To: Prospective Bidders
From: Wold Architects and Engineers
Date: October 23, 2017
Comm. No: 173040
Subject: Addendum No. 1 for Bidding Documents for the Scott County Courthouse Second Floor Clerks Renovations

1. SHEET A6.41 – DETAILS – INTERIOR

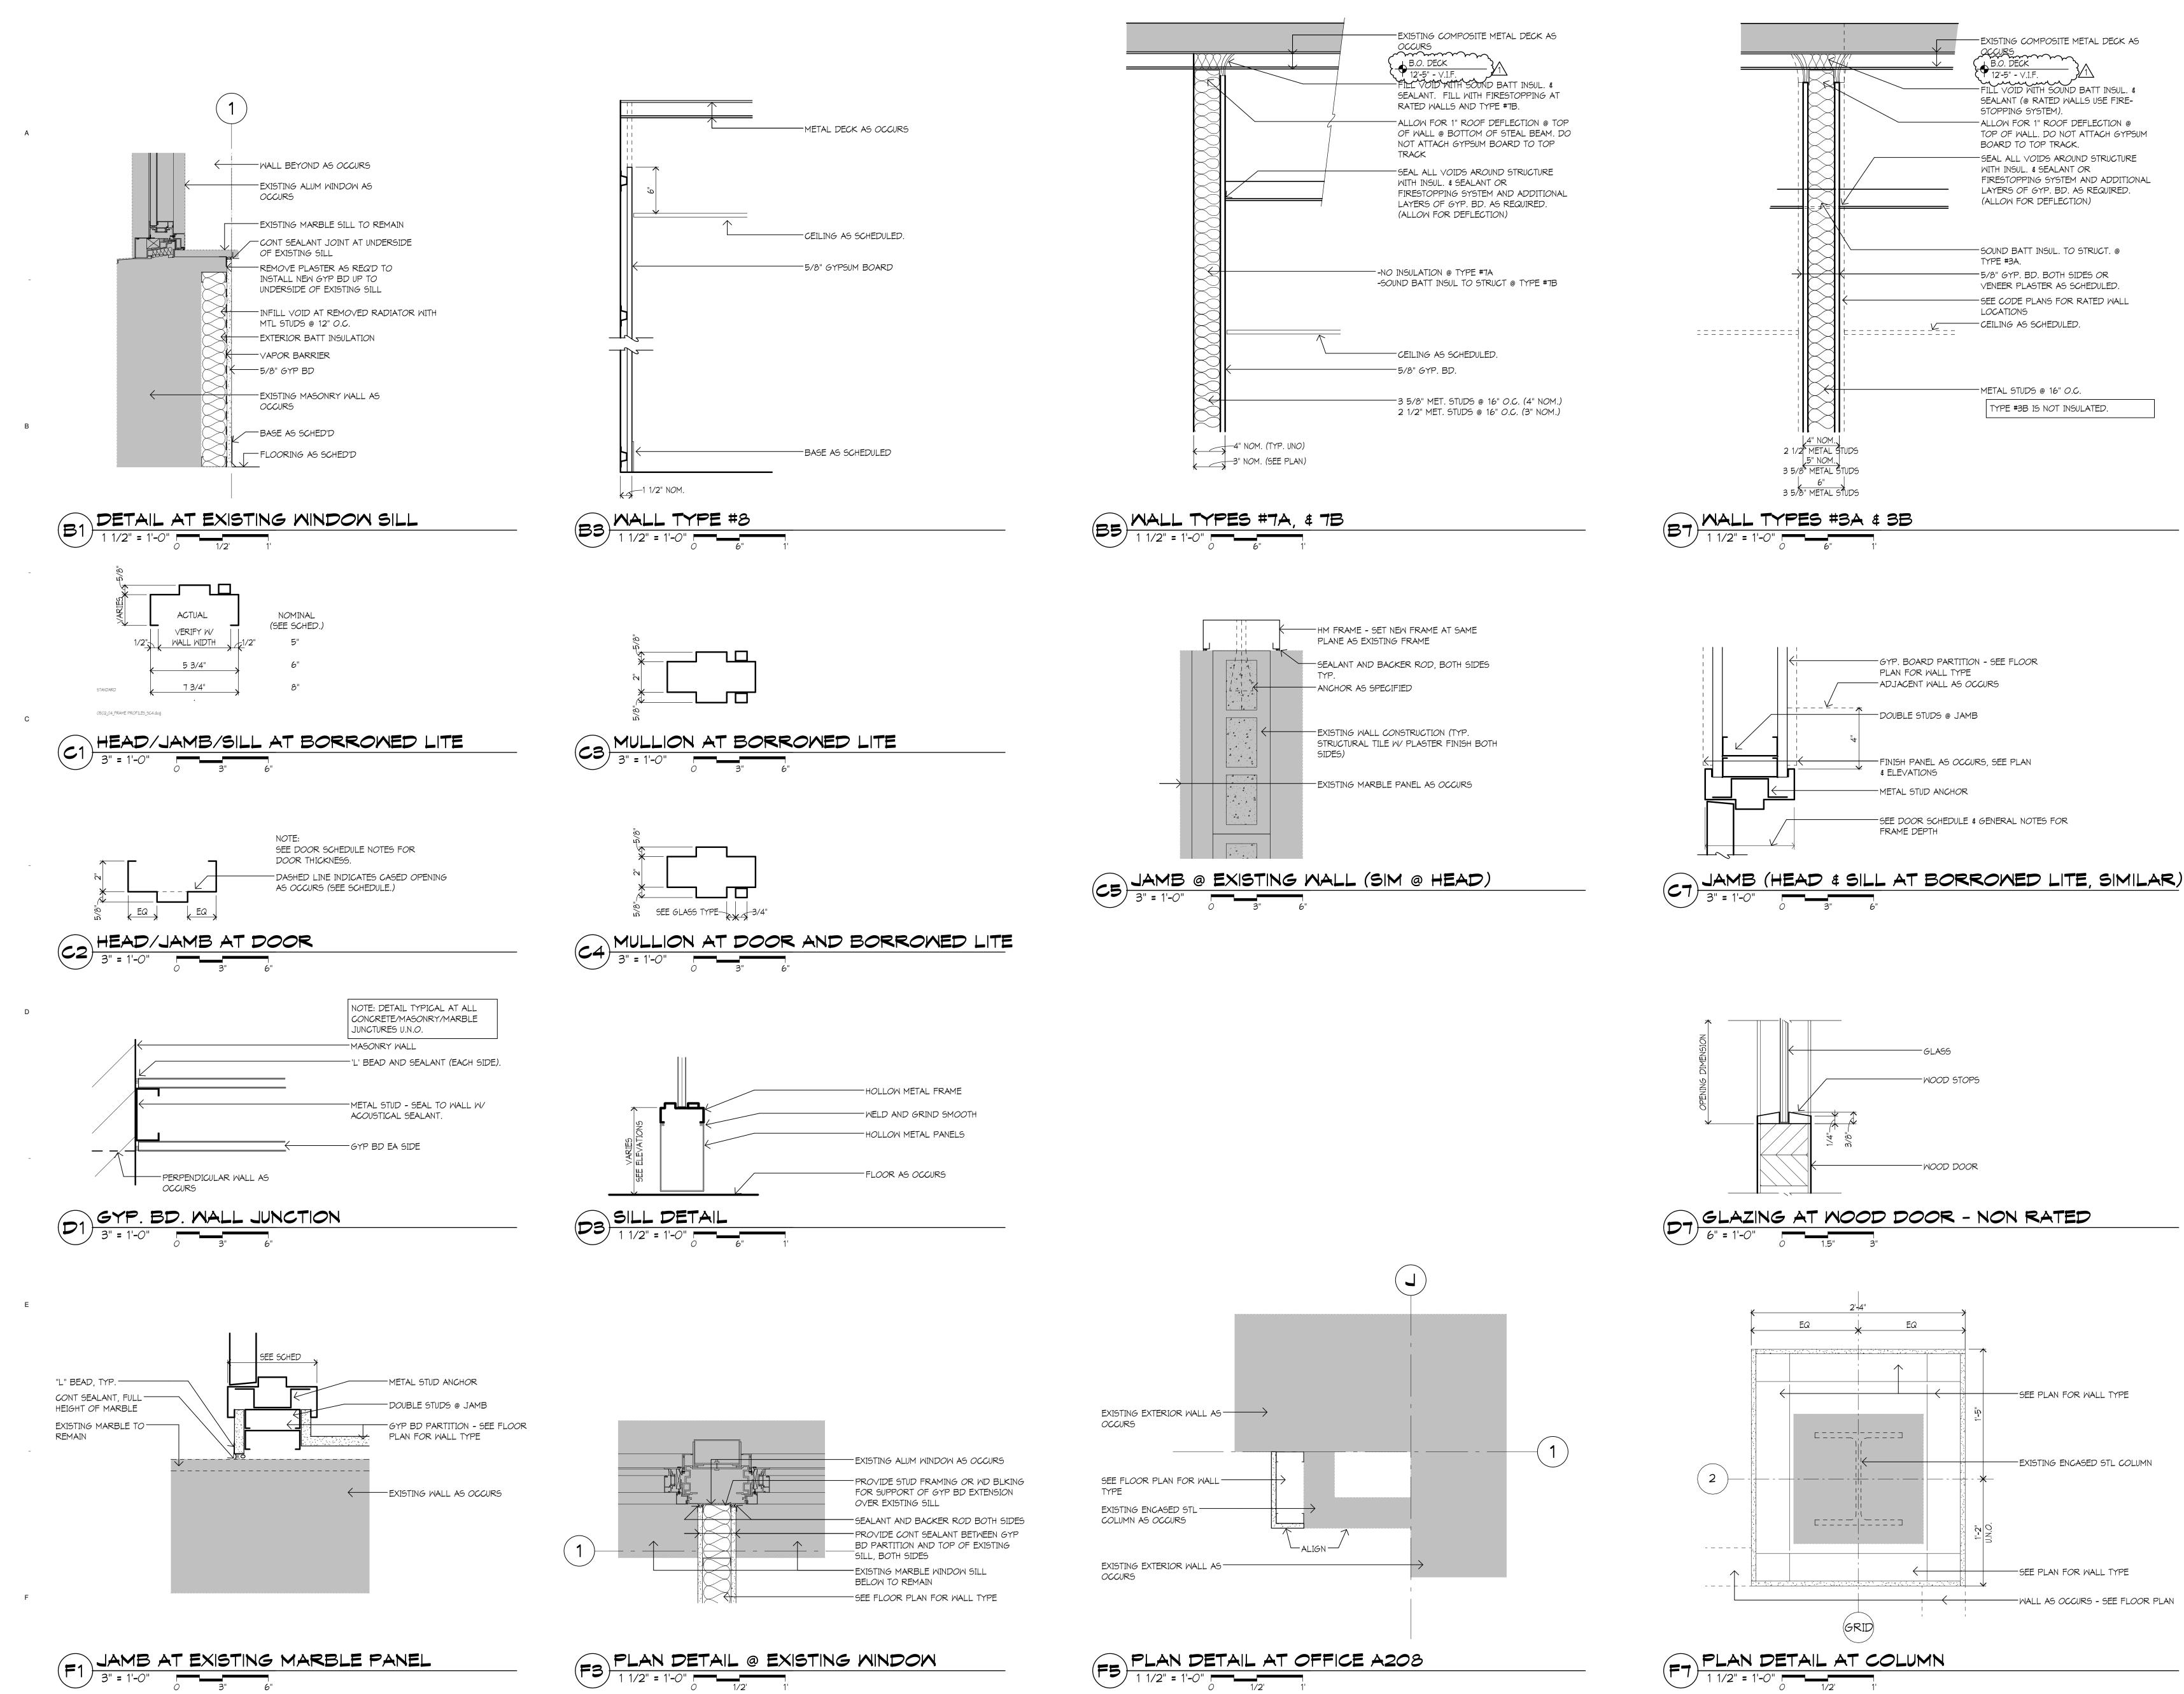
A. Refer to attached Sheet A6.41 for revisions at Details B5 and B7.
